Proposed changes to P802.3dj MPI and DGD penalty specifications

John Johnson, Broadcom

Implementation details for P802.3dj D2.0 comments #15-35, 286-288

Figure 180-3—OMA_{outer} each lane (max) and OMA_{outer} each lane (min) versus max(TECQ, TDECQ)

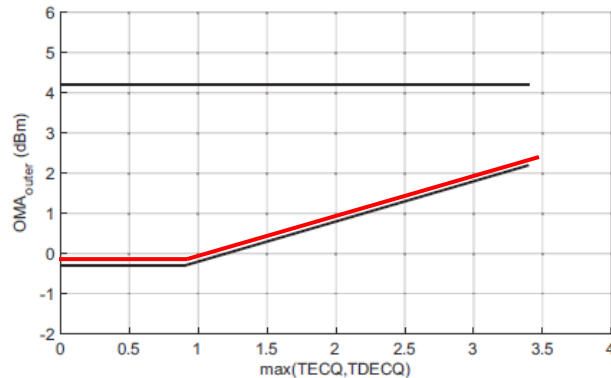
- Change the values in Table 180-7 as shown in **red**
- Update footnote b:
 - An average launch power of **-3.1** dBm corresponds to an OMA of **-0.1** dBm with an infinite extinction ratio.
- Update Figure 180-3 to match the changes to OMA_{outer} in Table 180-7.

Figure 180-5—Transmitter OMA_{outer} each lane versus max(TECQ, TDECQ) and receiver sensitivity (OMA_{outer}) each lane versus TECQ

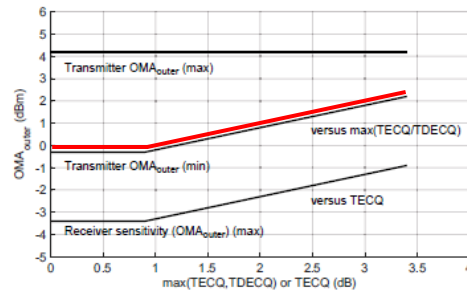
- Change the values in Table 180-9 as shown in **red**
- Update footnote b:
This channel insertion loss may be reduced by up to **0.5 dB** depending on ...
- Update footnote c:
...includes an allocation of **0.1 dB for MPI penalty and 0.2 dB for DGD penalty**. ... the allocation for penalties should be “**6.7 – channel insertion loss**”.
- Update Figure 180-5 to match the changes to TX OMA_{outer} in Table 180-7.

Figure 181-3—OMA_{outer} each lane (max) and OMA_{outer} each lane (min) versus max(TECQ, TDECQ)

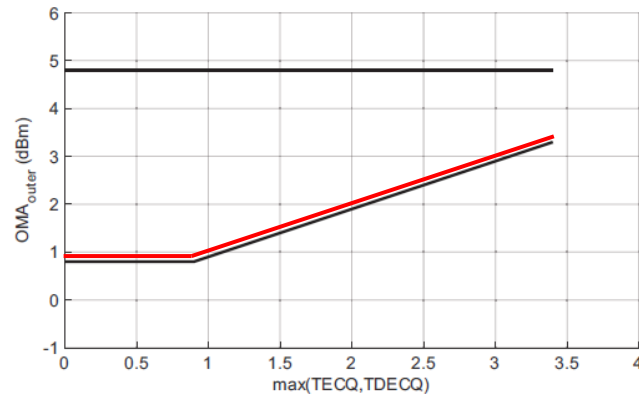
- Change the values in Table 181-5 as shown in **red**
- Update footnote b:
 - ^b An average launch power of **-2.1** dBm corresponds to an OMA of **0.9** dBm with an infinite extinction ratio.
- Update Figure 181-3 to match the changes to OMA_{outer} in Table 181-5.

Figure 181-5—Transmitter OMA_{outer} each lane versus max(TECQ, TDECQ) and receiver sensitivity (OMA_{outer}) each lane versus TECQ

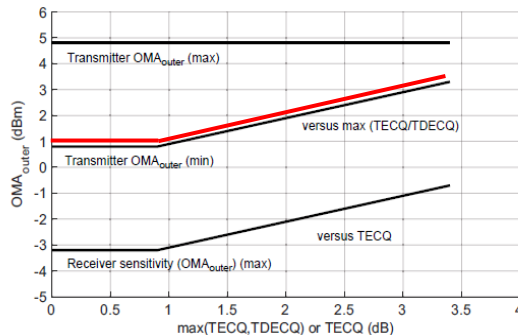
- Change the values in Table 181-7 as shown in **red**.
- Update footnotes b and c following the form of Table 180-9, with appropriate changes shown in **red**.
- Table 181-xx refers to the new table of maximum channel insertion loss to be added to CL 181.8.2.
- Update Figure 181-5 to match the changes to TX OMA_{outer} each lane (min) versus max(TECQ, TDECQ) in Table 181-5.

Figure 182-3—OMA_{outer} each lane (max) and OMA_{outer} each lane (min) versus max(TECQ, TDECQ)

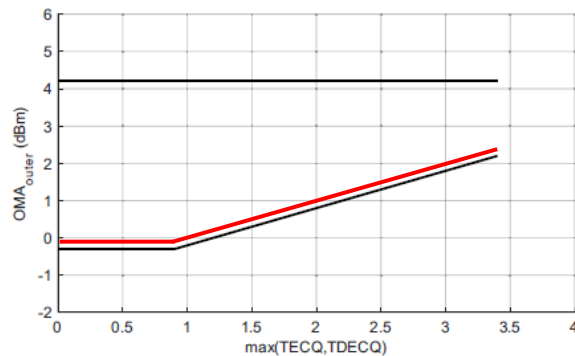
- Change the values in Table 182-7 as shown in **red**
 - Note that these are the same TX specs as CL 180 for component commonality
- Update footnote b:
 - An average launch power of **-3.1** dBm corresponds to an OMA of **-0.1** dBm with an infinite extinction ratio.
- Update Figure 182-3 to match the changes to OMA_{outer} in Table 182-7.

Figure 182-4—Receiver sensitivity ($\text{OMA}_{\text{outer}}$), each lane (max)

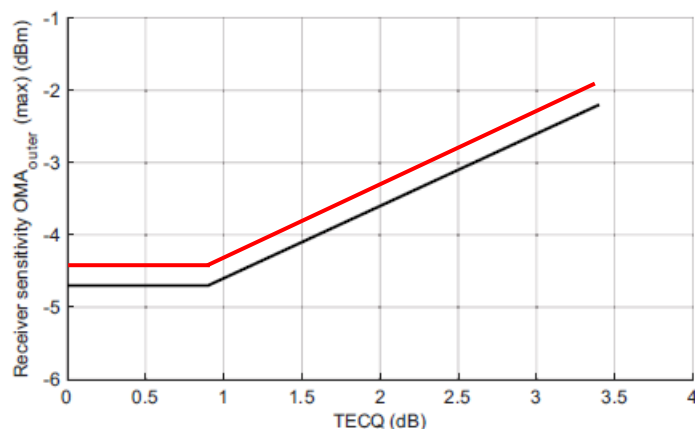
- Change the values in Table 182-8 as shown in **red**
- Update Figure 182-4 to match the changes to Receiver sensitivity ($\text{OMA}_{\text{outer}}$) in Table 182-8.

Figure 182-5—Transmitter OMA_{outer} each lane versus max(TECQ, TDECQ) and receiver sensitivity (OMA_{outer}) each lane versus TECQ

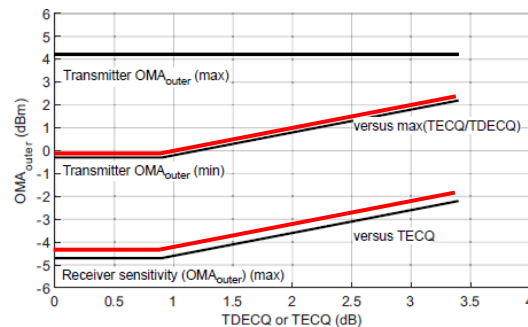
- Change the values in Table 182-9 as shown in **red**
- Update footnotes b and c following the form of Table 180-9, with appropriate changes shown in **red**.
- Table 182-xx refers to the new table of maximum channel insertion loss to be added to CL 182.8.2.
- Update Figure 182-5 to match the changes to OMA_{outer} in Tables 182-7 and 182-8.
